10 July 2020

Richland Parks and Recreation Building | City of Richland  
WBA Project No. 2619

## ADDENDUM NO. 03

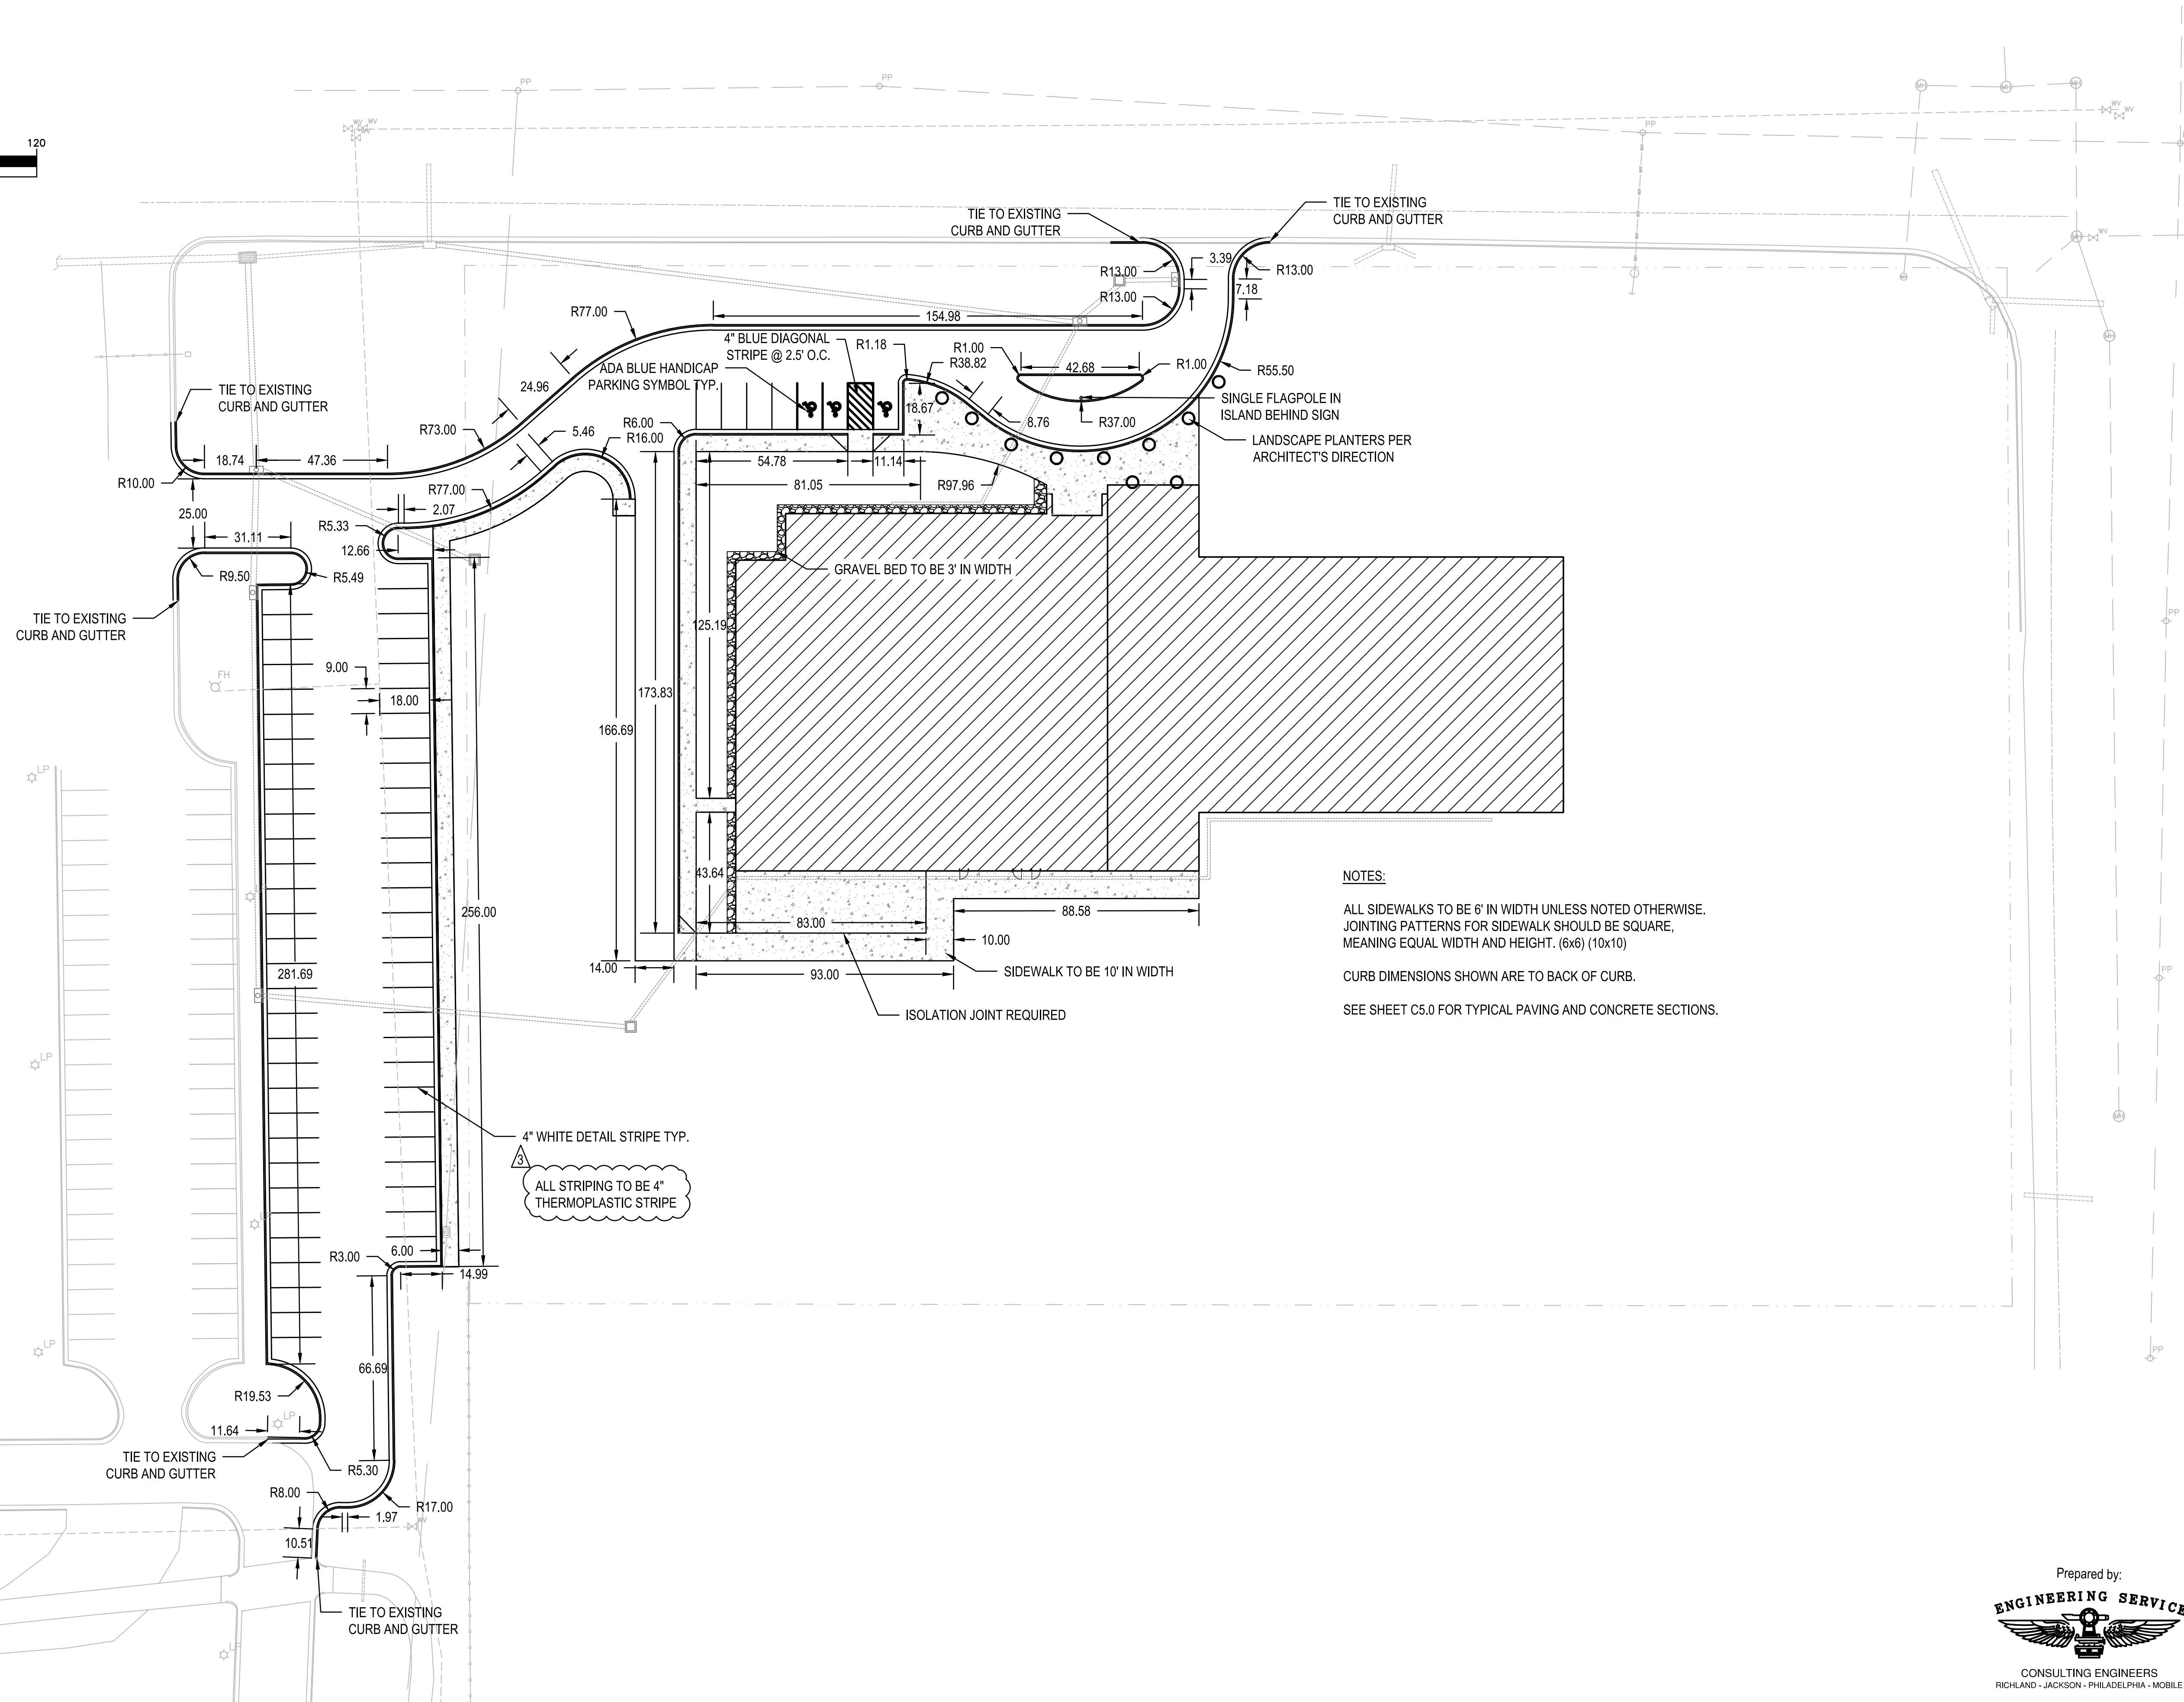
- ITEM NO. 06**      **SHEET C2.0 PROPOSED SITE LAYOUT**  
**DELETE** sheet in its entirety and **REPLACE** with enclosed sheet. **CLARIFIES** striping requirements.
- ITEM NO. 07**      **SHEET C2.1 PROPOSED GRADING PLAN**  
**DELETE** sheet in its entirety and **REPLACE** with enclosed sheet. **CLARIFIES** earthen berms.

**C6.1**  
 SOCCER FIELD DRAINAGE PLAN

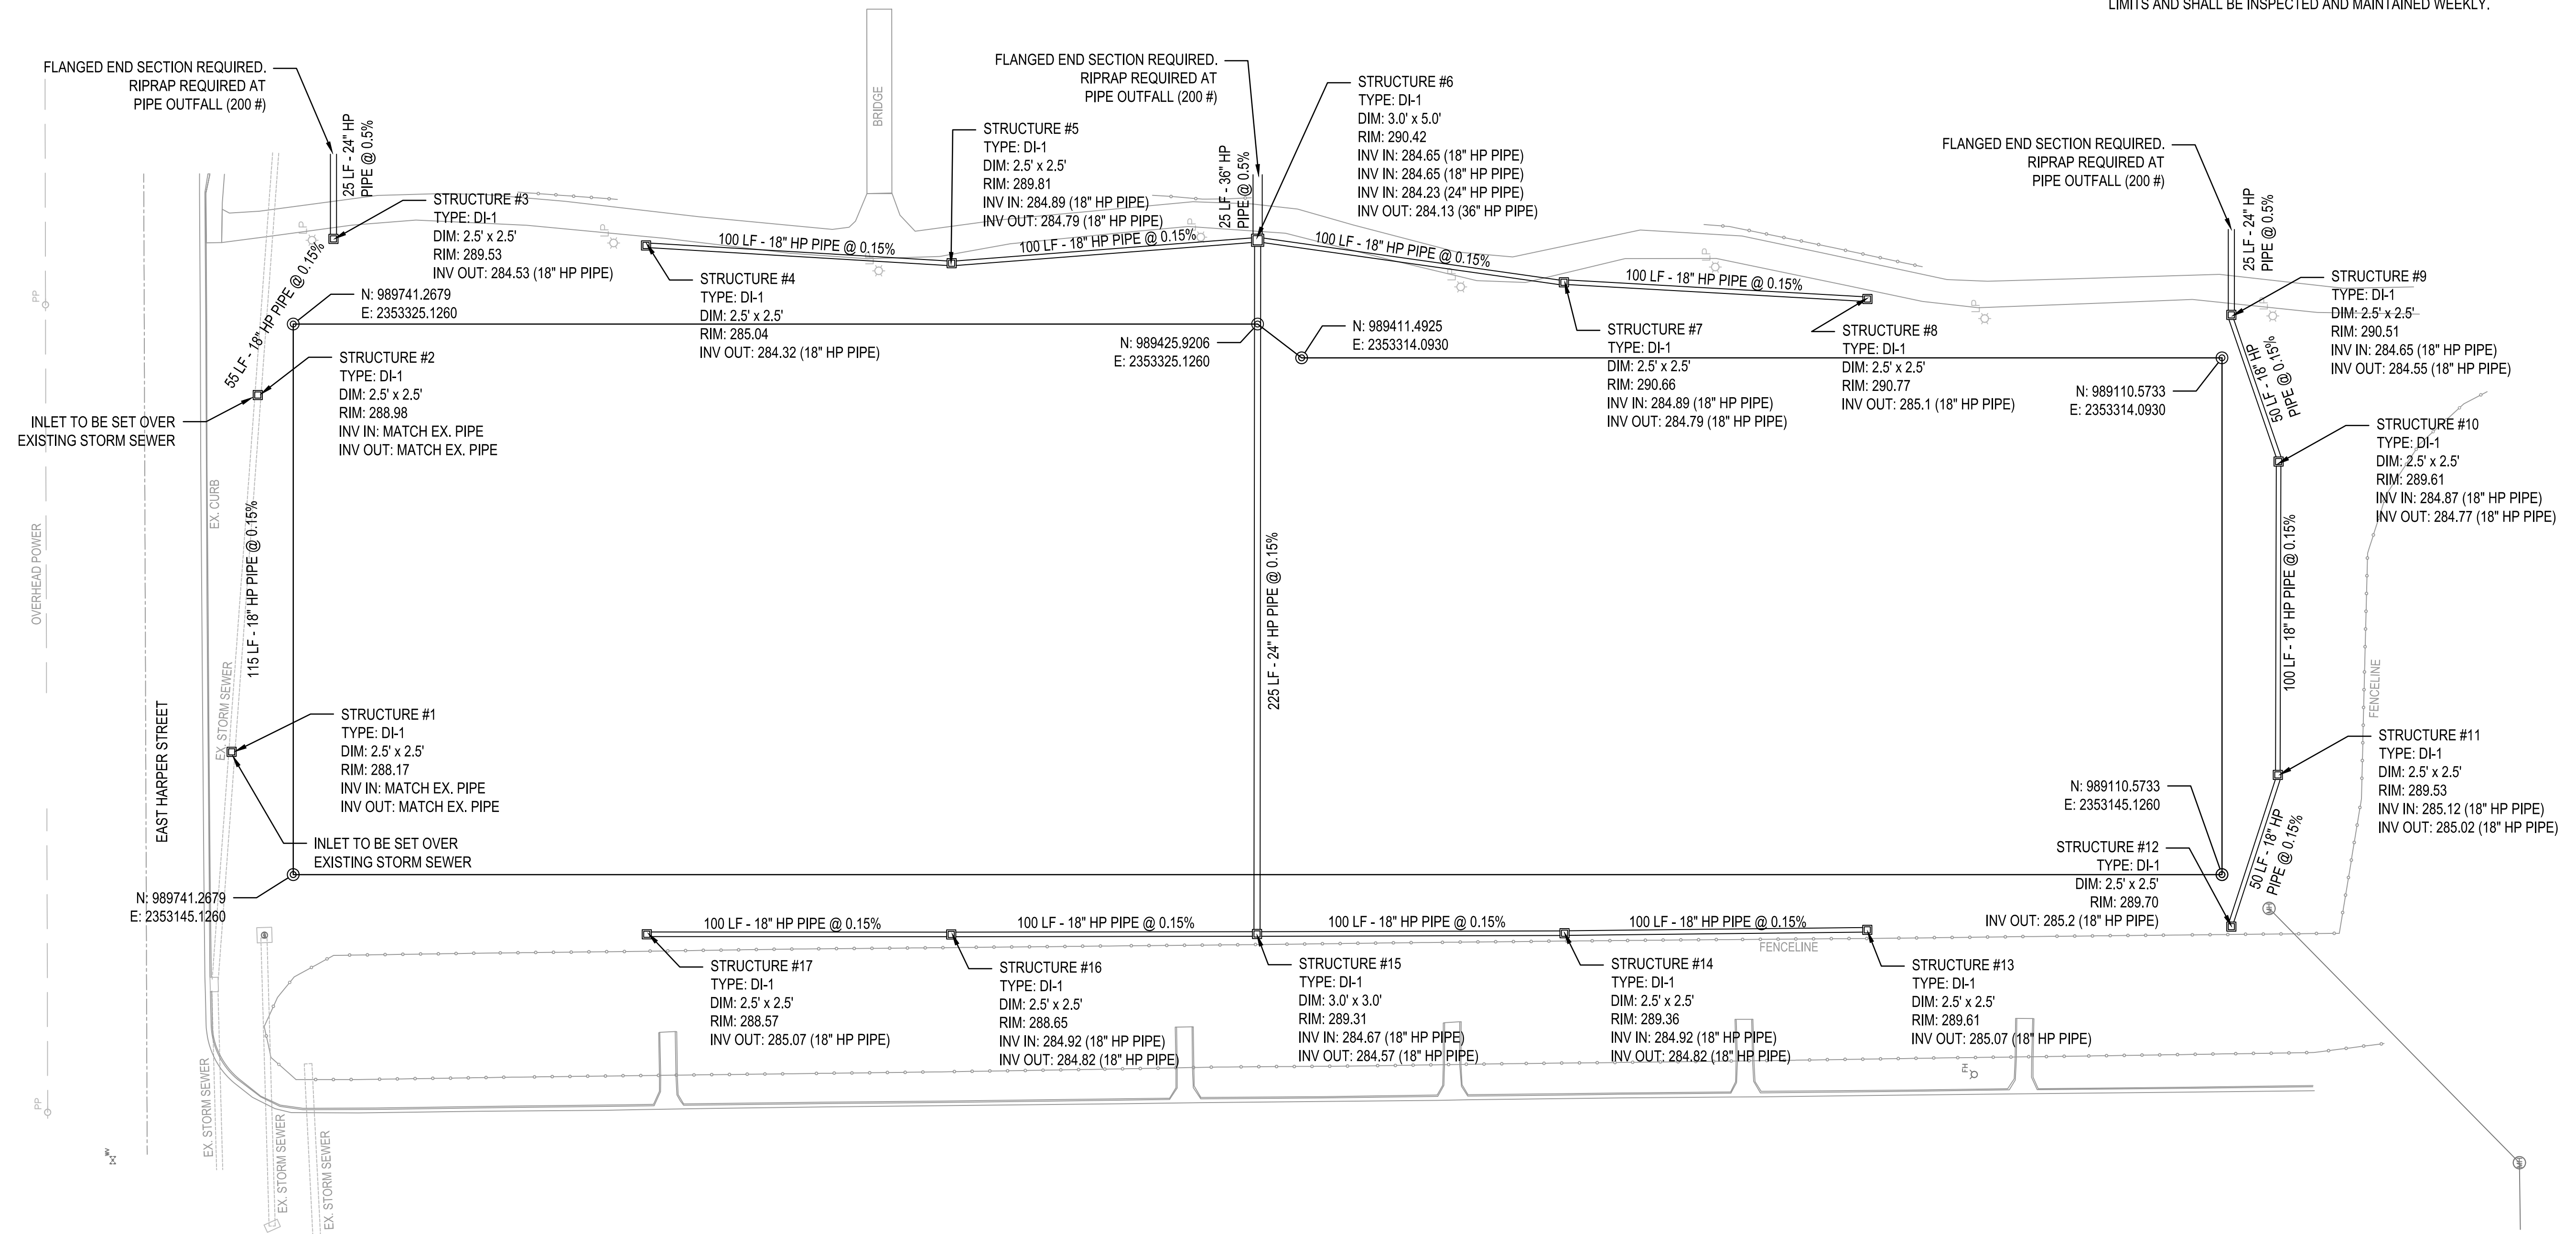
- ITEM NO. 09**      **SHEET C6.1 SOCCER FIELD DRAINAGE PLAN**  
**DELETE** sheet in its entirety and **REPLACE** with enclosed sheet. **ADD** sheet to the set.

**FOUNDATION PLAN - GYMNASIUM**  
1/8" = 1'-0"

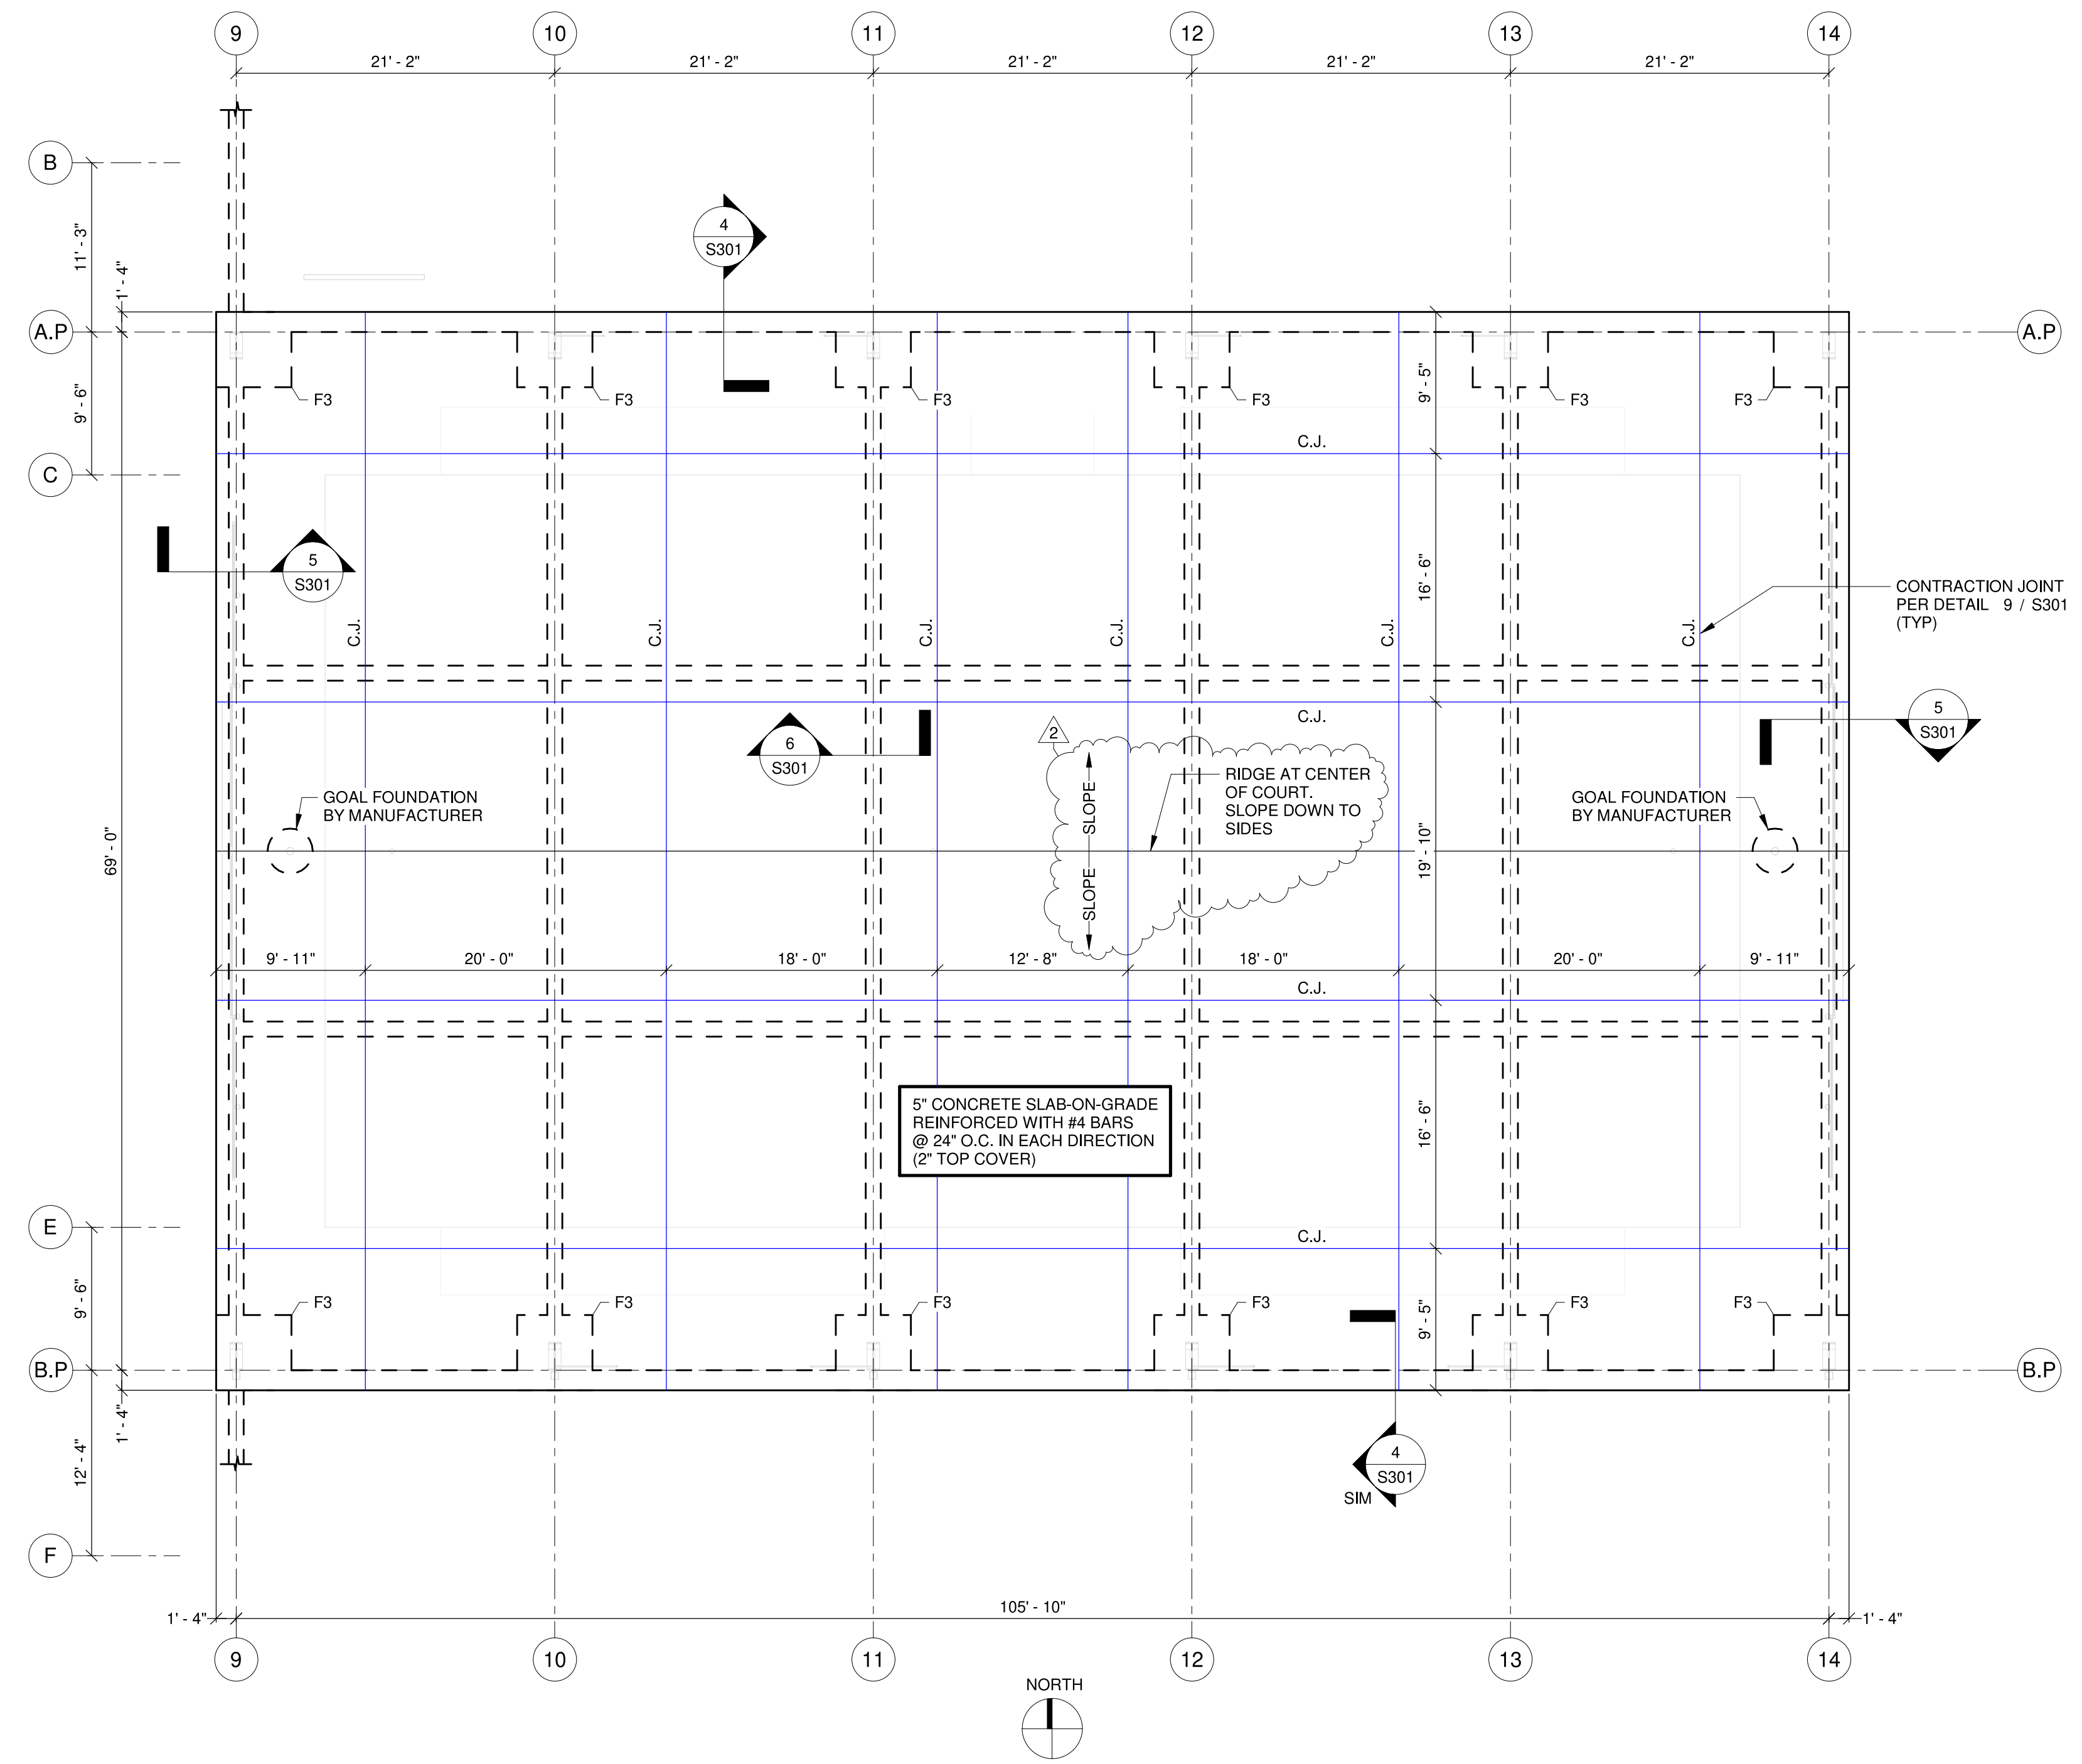
- ITEM NO. 10**      **SHEET S200 FOUNDATION PLAN - GYMNASIUM**  
**DELETE** sheet in its entirety and **REPLACE** with enclosed sheet. **ADD** grade beam clarification on Grid B;

**ADD** note about exterior slab.
- ITEM NO. 11**      **SHEET S201 FOUNDATION PLAN – COVERED COURT**  
**DELETE** sheet in its entirety and **REPLACE** with enclosed sheet. **ADD** note about slab edge.
